**Horse Heaven Wind Farm - FEIS  
Data Request No. 7  
March 22, 2023**

- The following table provides Scout’s responses to EFSEC’s data request No. 7 dated 4/20/2023. We have provided full responses where possible; however, some requested analysis will require additional time to prepare. In these instances, we have indicated that additional information will be provided under separate cover at a later date. These include the following Data Requests:
  - FEIS-Air-1
  - FEIS-Water-1
  - FEIS-Transpo-1
  - FEIS-Transpo-2

**Figure 1**  
Expected Shadow Flicker Impact Area  
244 Turbines (GE 2.82-127 89m)

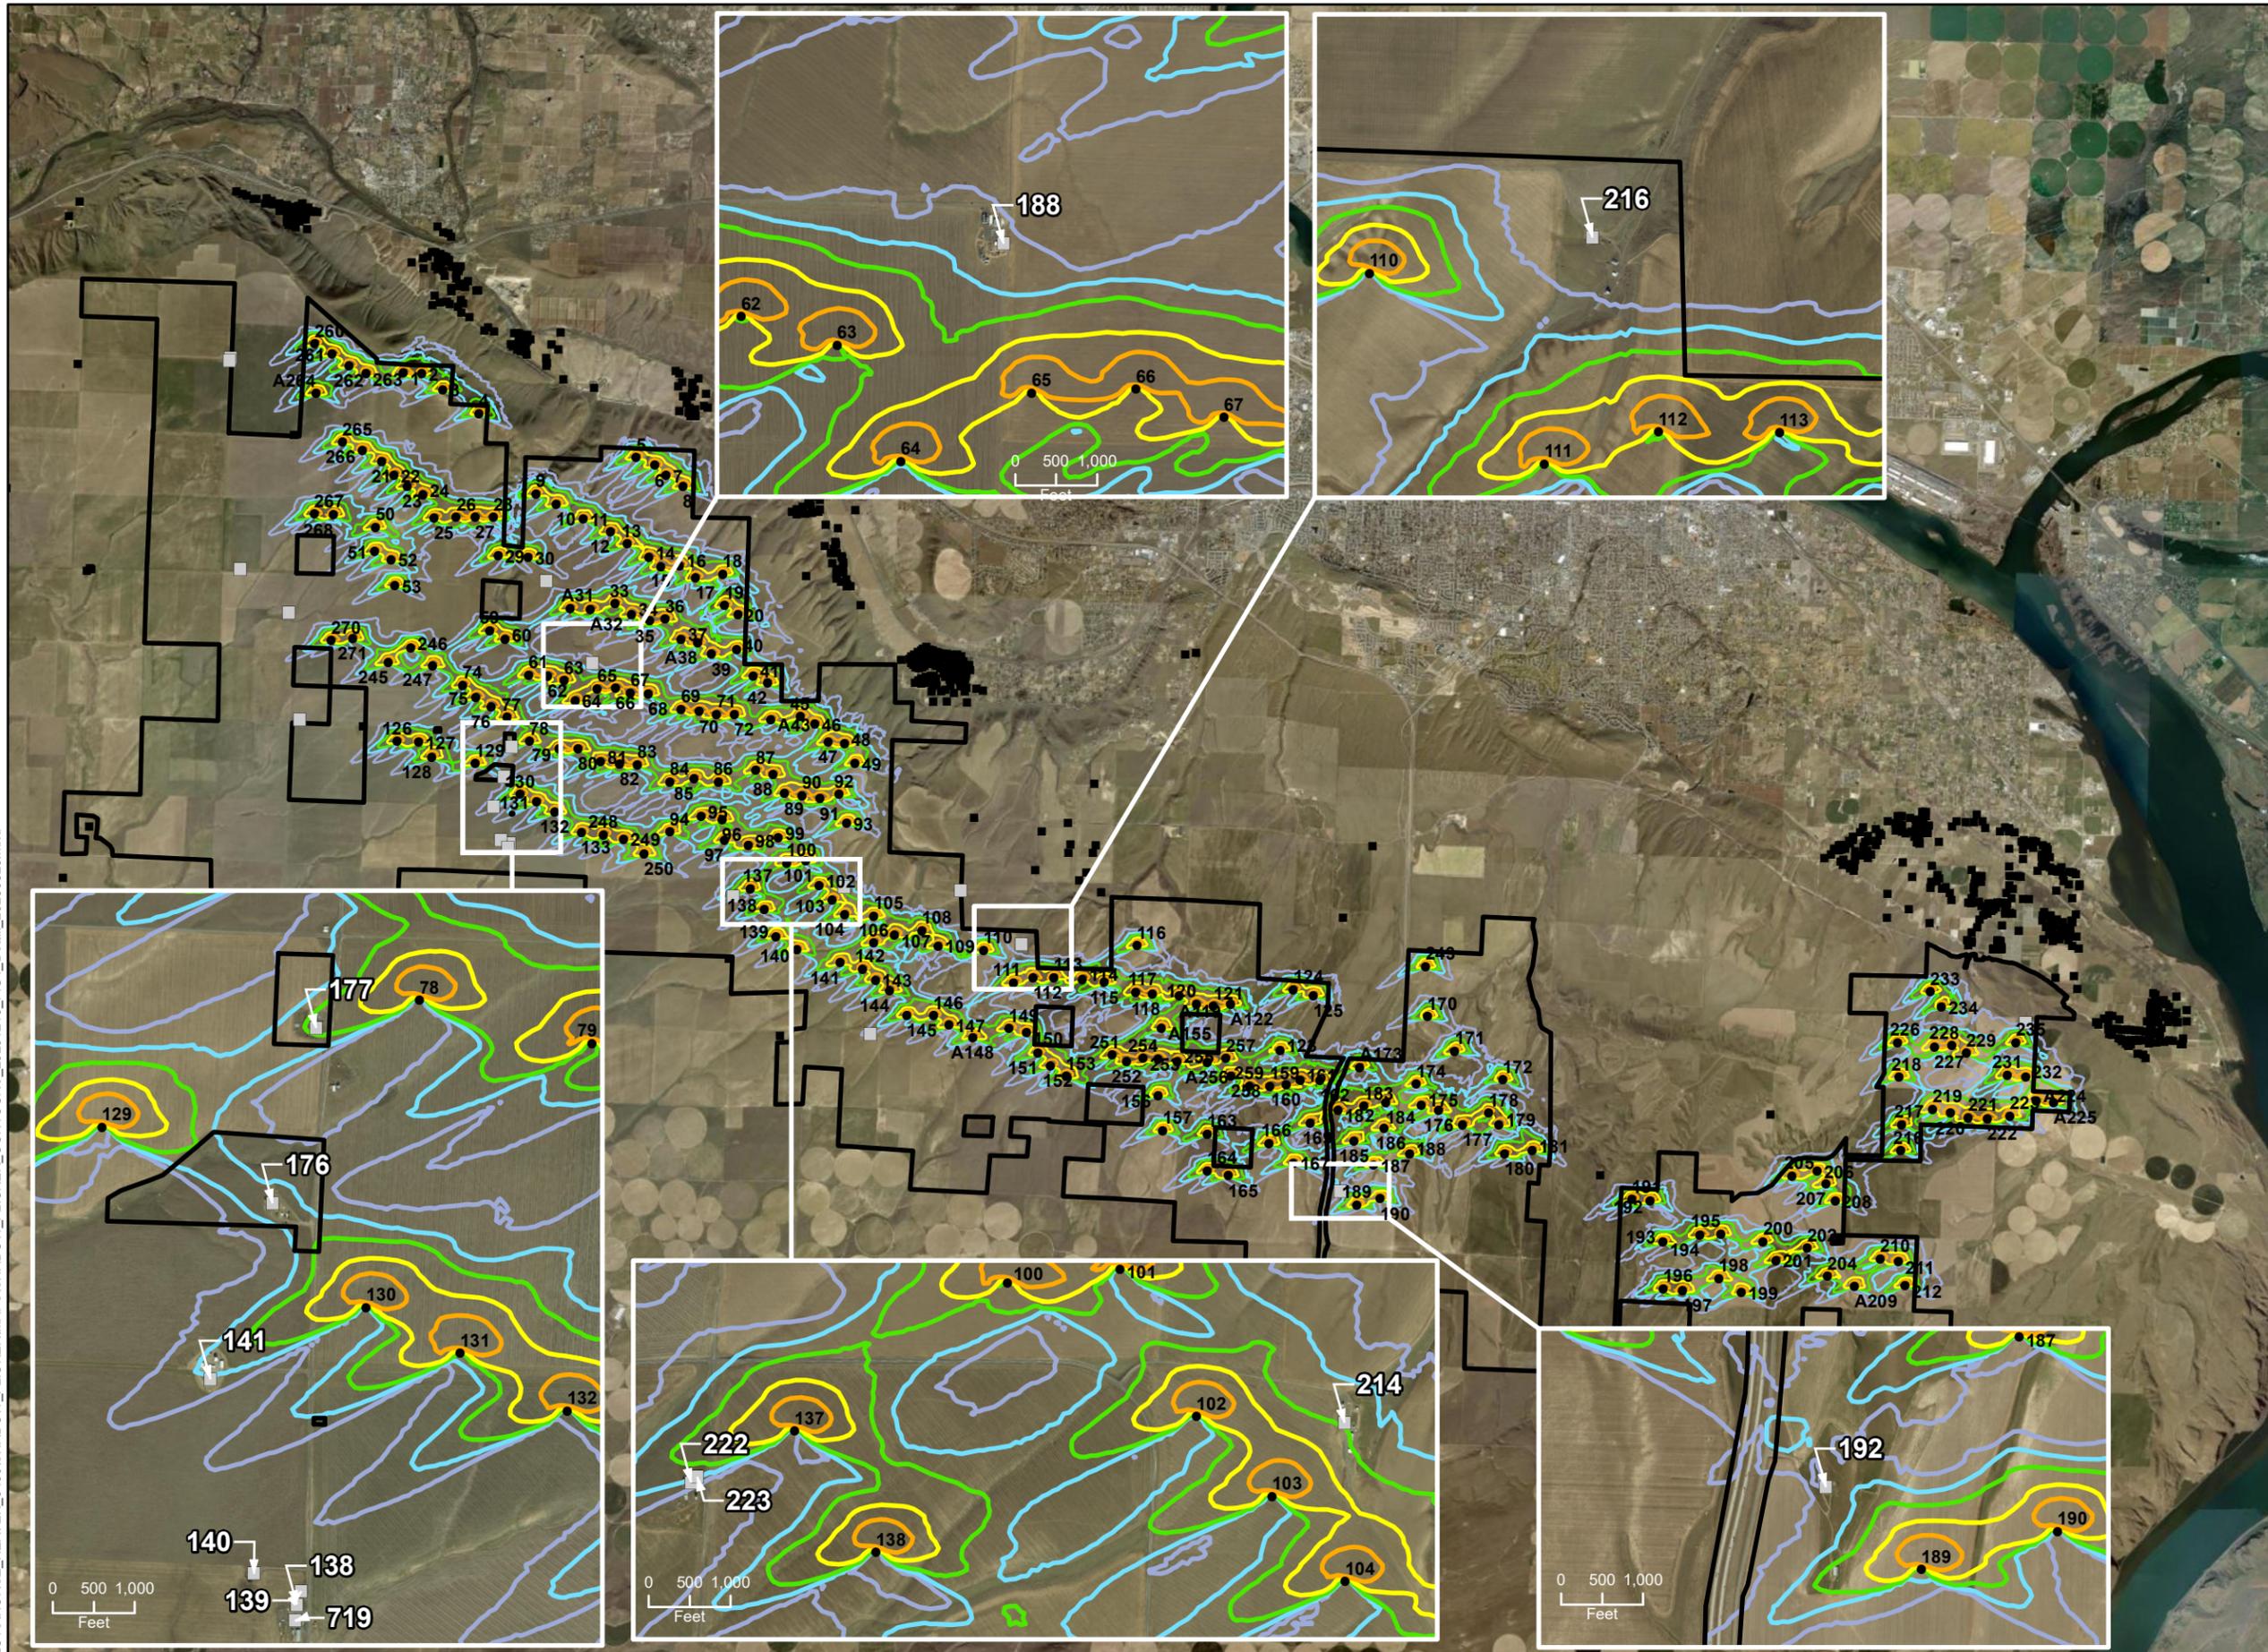
FEIS-Visual-3	4.10.2.2, Shadow Flicker	Turbine (Option 1 and Option 2) layout and receptor locations in areas of maximum impact	Based on public comments, wind turbine and receptor locations were not clear to the public, therefore zoomed in figures to show the closest turbine(s) and shadow flicker impacts at Receptor ID locations of maximum impact have been requested. These areas should include the Receptor ID locations identified in Tables 4.10-10 and 4.10-12. The figures need to be zoomed in enough so that IDs can be labeled and identified clearly on the figure(s).	<b>See Attachment FEIS-Visual-3 for figure with insets to show detail for the receptor IDs identified in the listed tables.</b>
FEIS-Noise-1	4.11.2.2	Turbine and noise receptor locations in areas of maximum impact.	Based on public comments, wind turbine and NSR locations were not clear to the public, therefore zoomed in figures to show the closest turbine(s) and noise impacts at the NSR and boundary locations of maximum impact have been requested. These areas should include those NSR locations identified in Tables 4.11-8 and 4.11-9. The figures need to be zoomed in enough so that NSR locations can be labeled and identified clearly on the figure(s).	<b>See Attachment FEIS-Noise-1 for figure with insets to show detail for the receptor IDs identified in the listed tables.</b>

# Attachment FEIS-Recreation-1

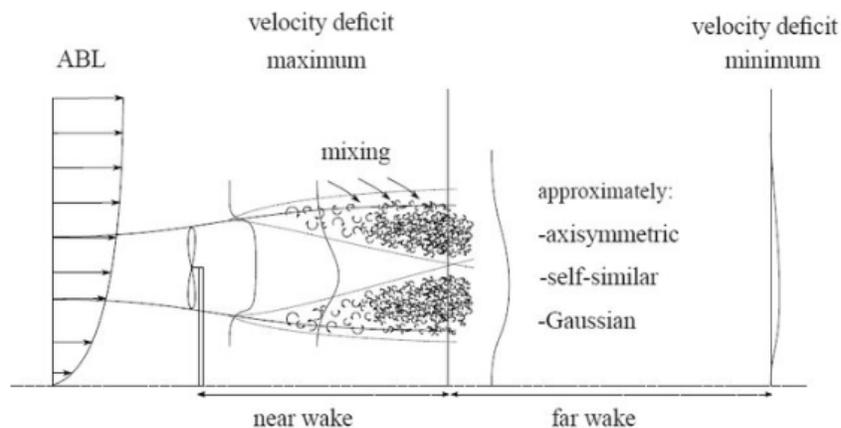
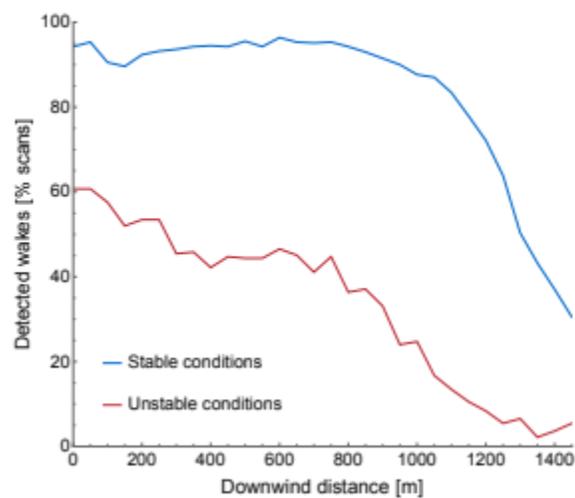
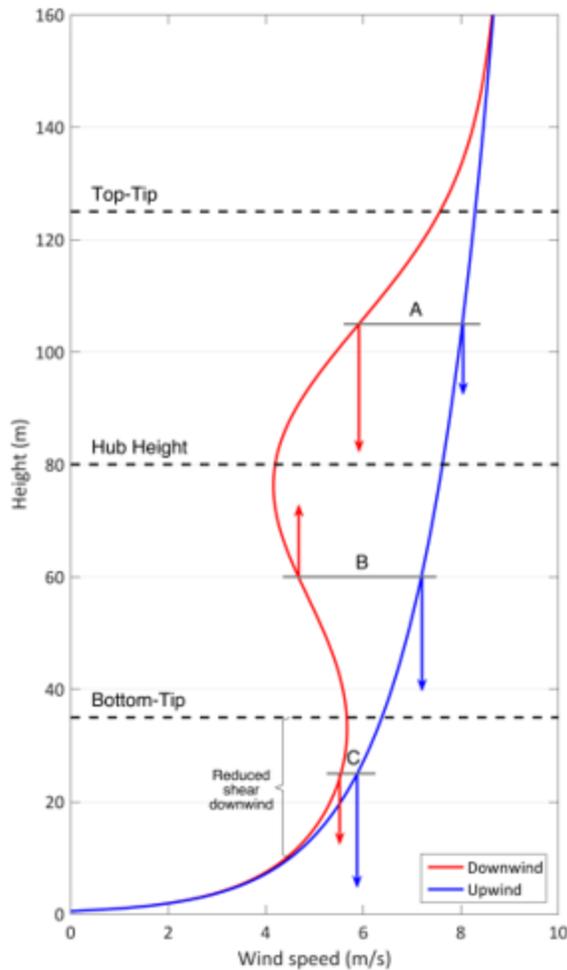
FEIS-Recreation-1	N/A	Downwind effects on recreation	What are the downwind effects (e.g., increase in turbulence, variability, etc.) on microclimates and how will these affect paragliding?	<p>Several studies have probed the physical structures of wind turbine wake zones and potential impact on light aviation. A summary of this information, along with reference source documentation, is provided in Attachment FEIS-Recreation-1. <b>The implications for light aviation traffic in the vicinity of a wind farm are as follows:</b></p> <ul style="list-style-type: none"> <li>• <b>At wind speeds above cut-in speed (approx. 7 mph), exercise caution if the flight path is within 10 rotor diameters (approx. 3,000 feet) downwind of the wind turbines. Note: the nose of a wind turbine always faces upwind and the rotor has a clockwise rotation.</b></li> <li>• <b>Atmospheric conditions can vary quickly causing changes in wind speed and direction, potentially causing unpredictable hazard within 10 rotor diameters (approx. 3,000 feet) downwind of the wind turbines.</b></li> </ul>
